METROPOLITAN GOVERNMENT OF NASHVILLE AND DAVIDSON COUNTY

STAFF RECOMMENDATION 406 A & B Rudolph Avenue November 19, 2014

Application: New construction-infill and outbuildings; Setback determination
District: Lockeland Springs-East End Neighborhood Conservation Zoning Overlay
Council District: 06
Map and Parcel Number: 08310046900, 08310002600
Applicant: David Baird
Project Lead: Paul Hoffman, paul.hoffman@nashville.gov

Description of Project: The applicant proposes new construction of two residences with outbuildings on this vacant lot. A setback determination is requested for the outbuildings on the alley from ten feet (10') to five feet (5').

Figure 2. Site plan showing setbacks for these undersized lots

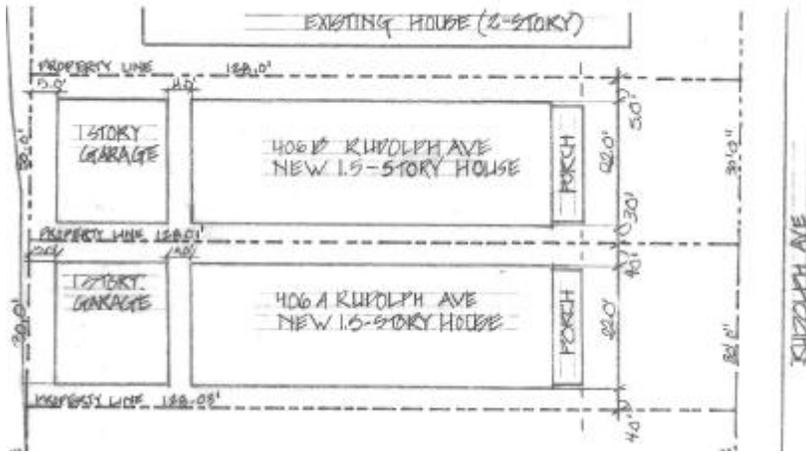
Setback & Rhythm of Spacing: The proposed infill will be twenty-eight feet (28') from the front of the property, which matches the front setback of the adjacent contributing houses. 406A will be centered on the lot with side setbacks of four feet (4') on each side. 406B will be three feet (3') from the interior side, and five feet (5') from the outside property line. As these are legally created lots less than the required minimum lot area for the R6 zoning, the infill may be built to the three foot (3') side setback (Ordinance No. BL2013-419). The rear setback will be thirty feet (30') from the rear line, which meets the twenty foot (20') rear setback requirement. The project meets section II.B.3.

Date: 10.17.2014
UNIT A ROOF PLAN

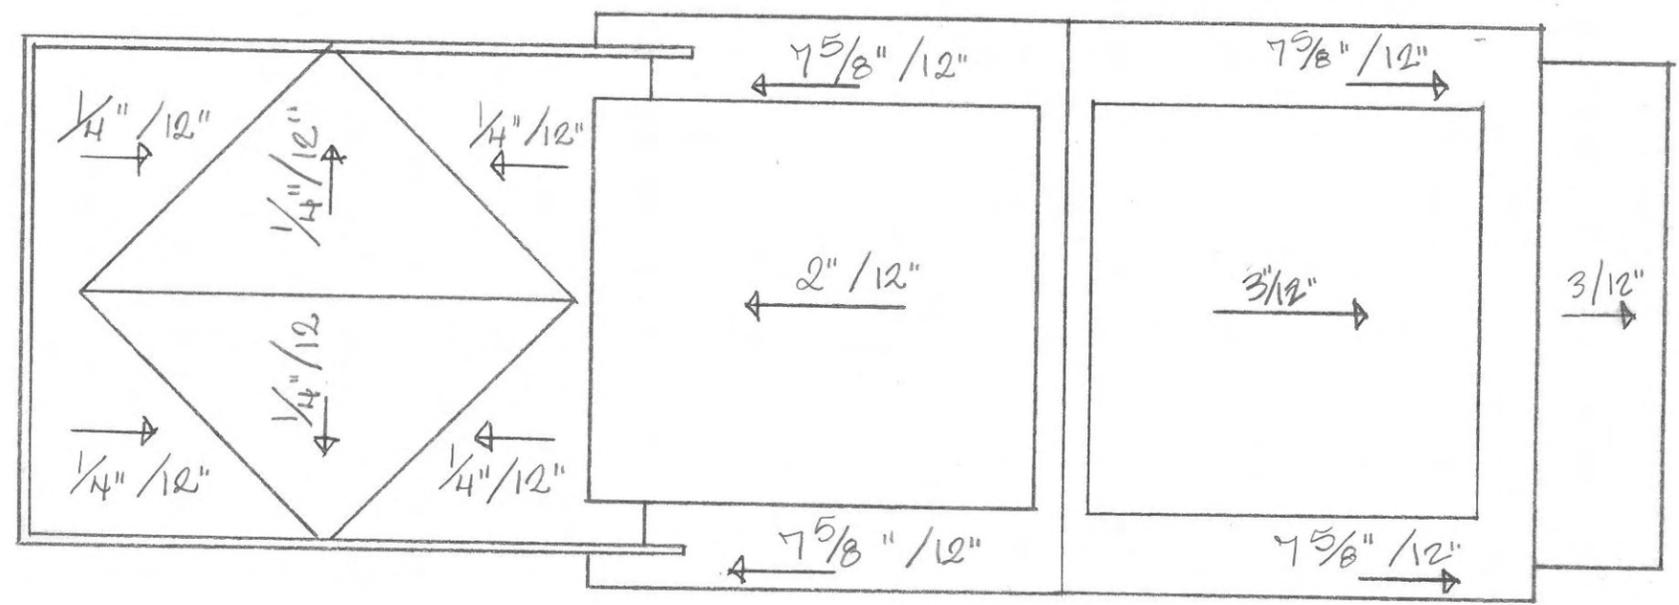
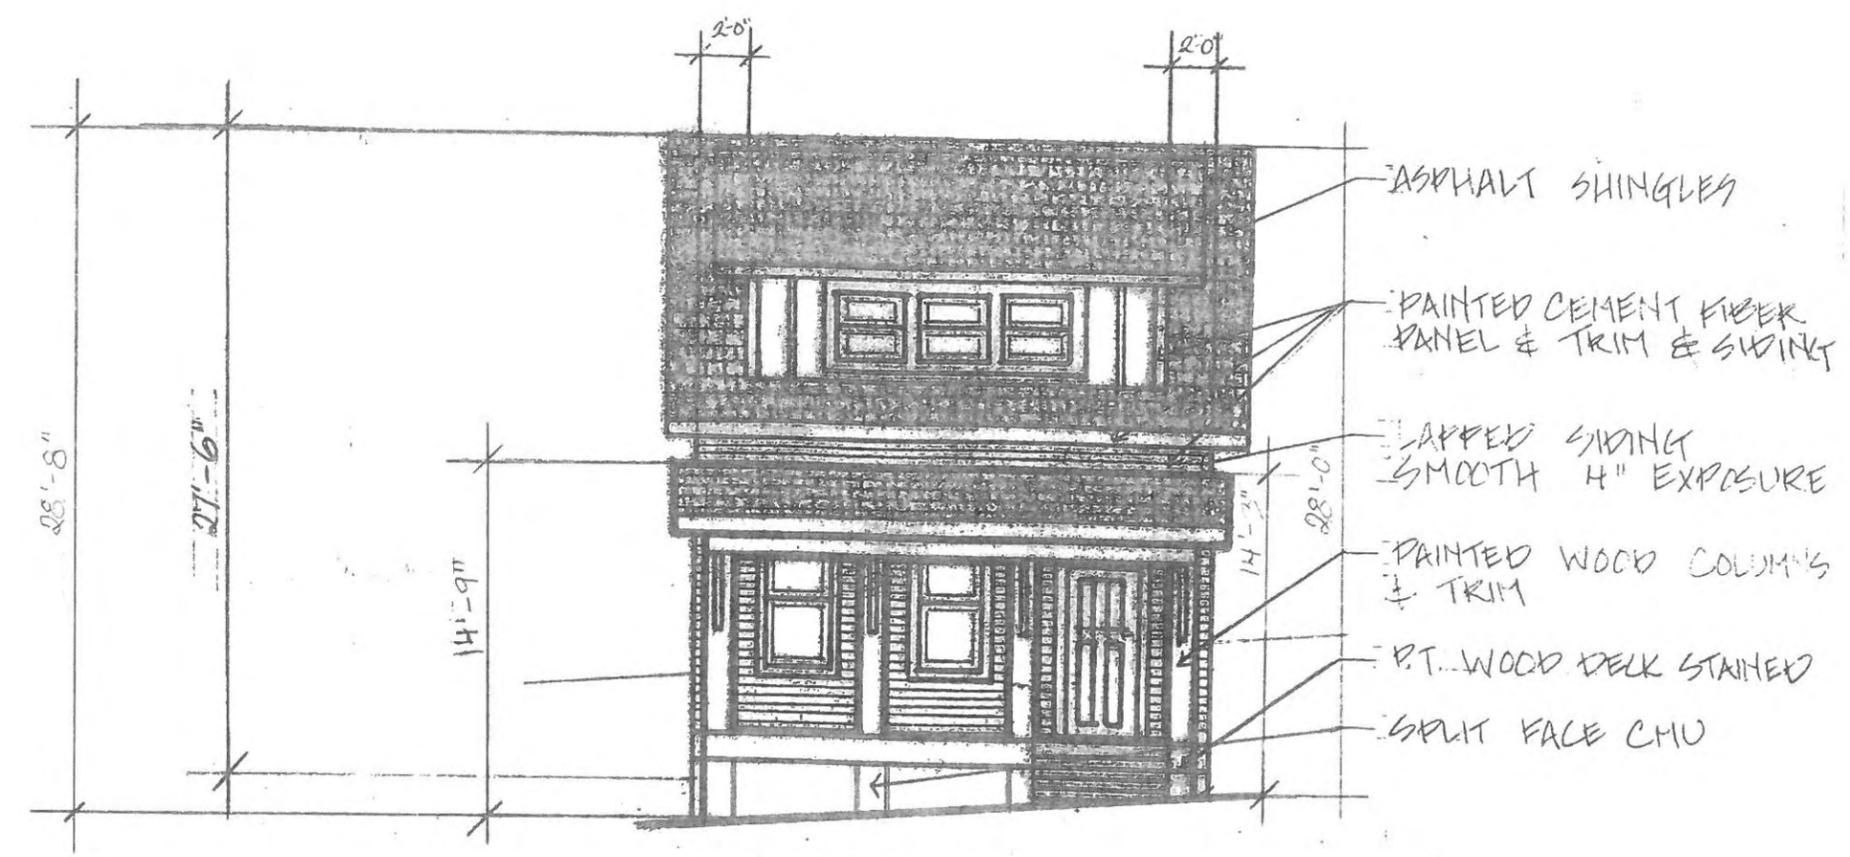
Roof form: The buildings will have side gabled roofs with 7/12 pitch. 406A has a shed dormer on the front roof with 2/12 pitch. 406B has a gabled dormer on both the front and rear roofs, with 6/12 pitch. The dormer sits two feet (2') back from the front wall. The front dormers are approximately nineteen feet (19') wide each. The front roof plane is twenty-three feet (23') wide. The front dormers take up more than eighty percent (80%) of the front roof surface. Staff requests the dormers be reduced in width to fifty percent (50%) or less, to be more compatible with historic dormers.

The porch roofs as drawn leave approximately one foot (1') of siding area between the primary roof and the porch roof. To make the buildings more compatible with historic form, Staff recommends the porch roofs be brought upward, to engage with the primary roof of each house (Figure 3).

1. A walkway be added to connect each unit to Rudolph Avenue;
2. The dormers be reduced in width to fifty percent (50%) or less of the roof width, to be more compatible with historic dormers;
3. A six inch (6") inset be added on each side at the material break, to break up the flat plane there;
4. The porch roof be brought up to engage the primary roof plane;
5. The depth of the house be reduced, to meet the required twenty feet (20') between the houses and the outbuildings;
6. The finished floor height shall be consistent with the finished floor heights of the adjacent historic houses, to be verified by MHZC staff in the field;
7. Staff approve roofing color, and windows and doors prior to purchase and installation;
8. The HVAC shall be located behind the house or on either side, beyond the midpoint of the house.

UNIT A BUILDING ELEVATIONS

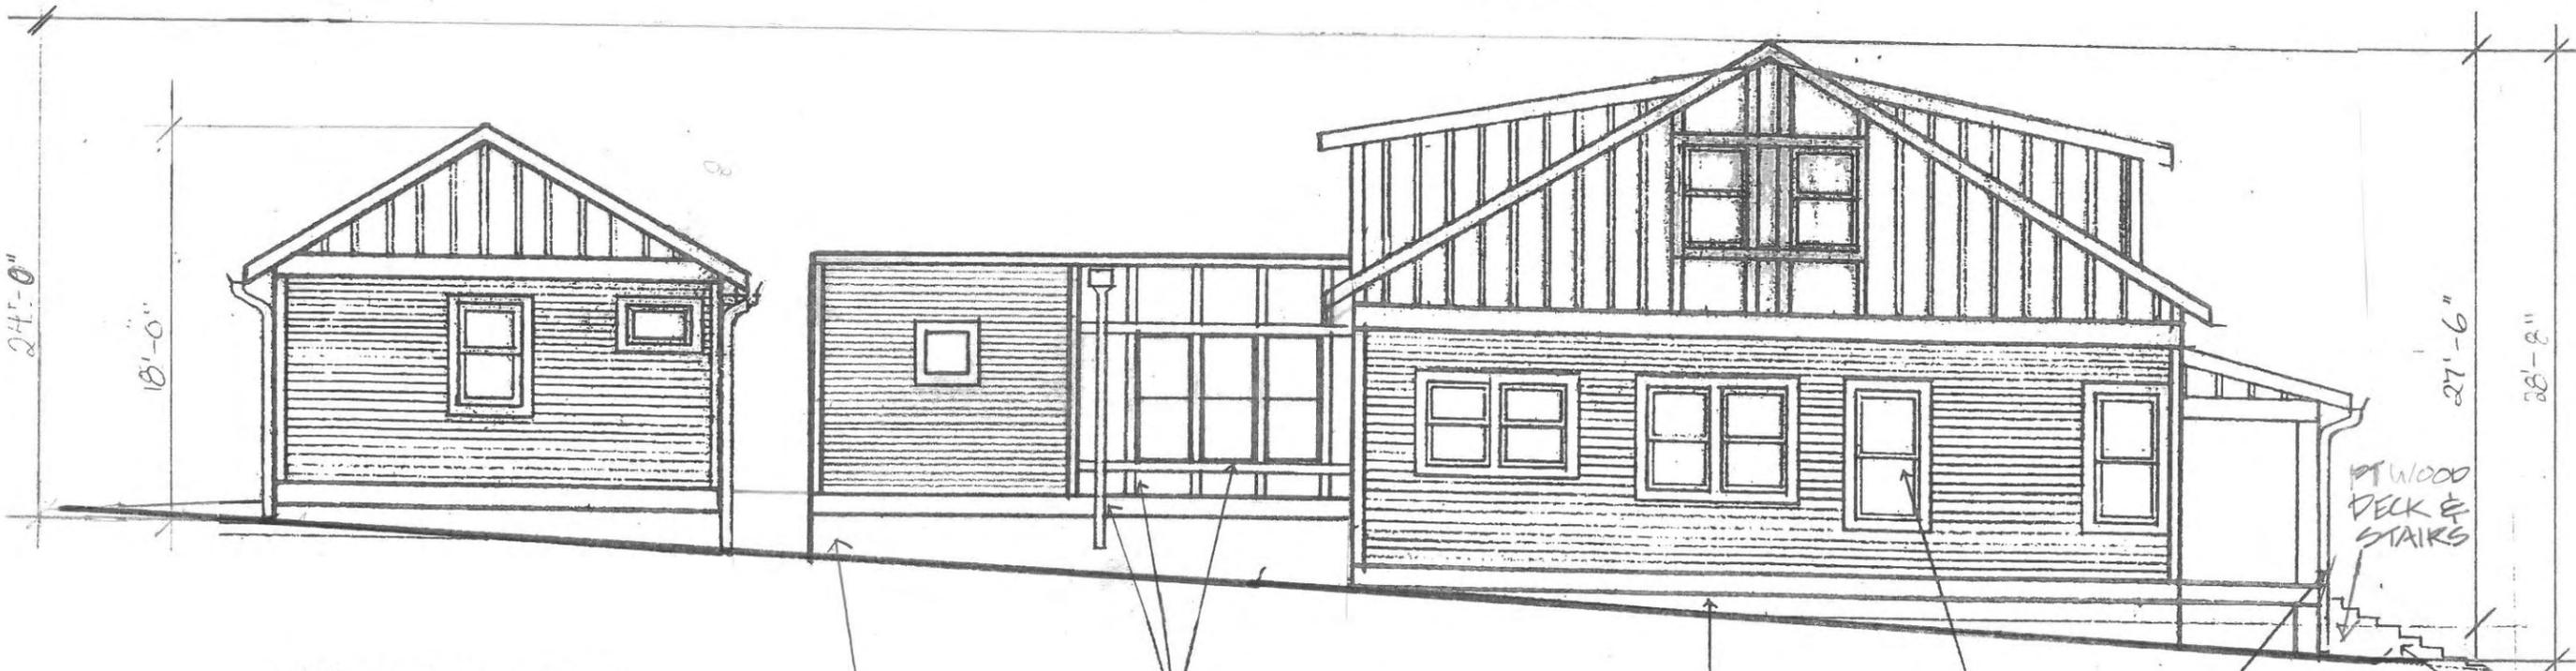
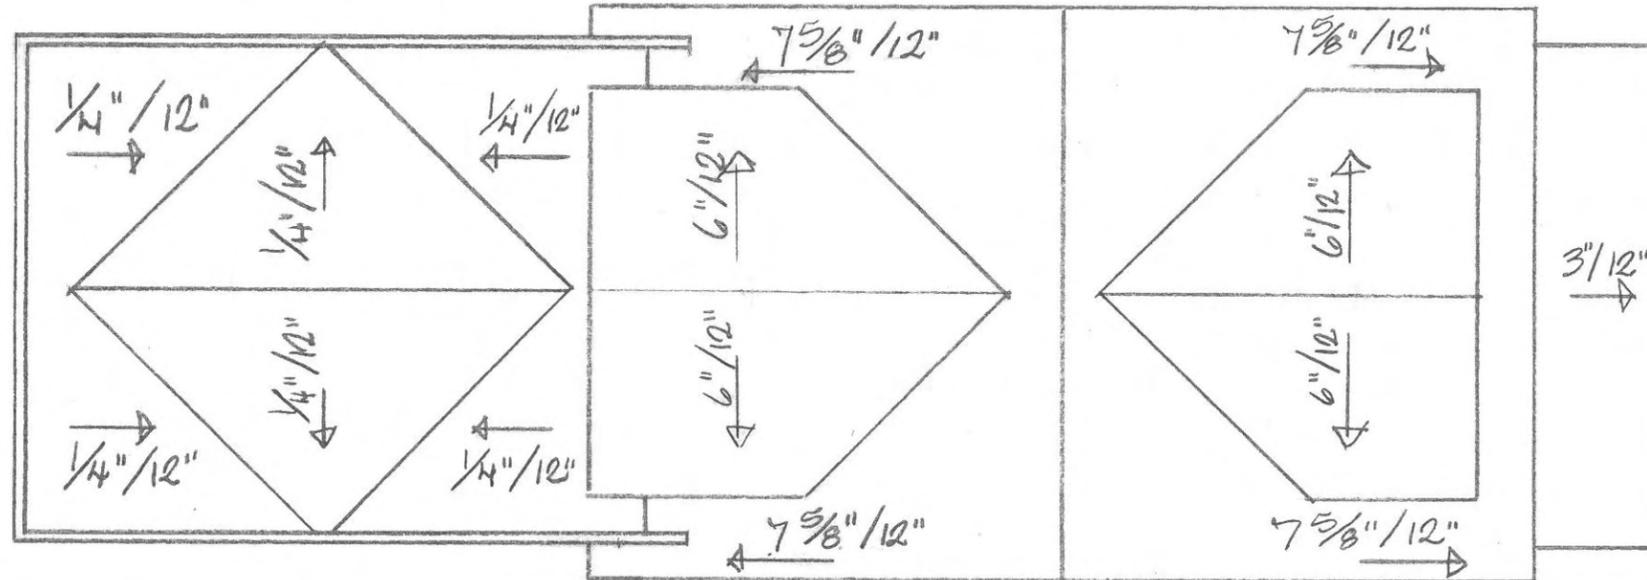
The side walls of the building extend sixty-five feet (65') from the front wall to the rear without any articulation. There is a material break from siding to board-and-batten from the front portion of the house to the rear wing. Even with the change of materials, these side walls would benefit from some relief from the flat plane as currently drawn. Staff therefore recommends a six inch (6") inset on each side of the buildings at the material break.
